## MEMORANDUM

To: Development Review Board  
From: Mary O'Neil, AICP, Principal Planner  
Date: November 8, 2023  
RE: ZP-23-474, 72-76 Elmwood Avenue

**Request:** Reapplication for expired permit ZP21-509; Build three unit detached residential structure on the site of the former Free Methodist Church. One existing single family residence remains on site. (Planned Unit Development)

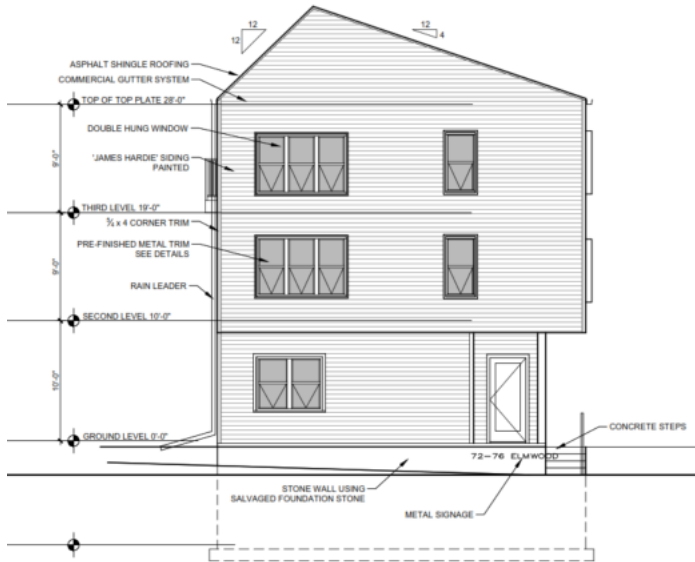
72-76 Elmwood Avenue has only one abutting neighbor; 68 Elmwood Avenue. It is a gable-and-eaves front 2 ½ story residential building. Across the street on the corner of Peru Street is a modified Dutch Colonial, and the much grander St. Joseph’s rectory. Although presenting eaves-front to the street, the height and massing of the proposed building is consistent with other structures in the immediate area. **Affirmative finding.**
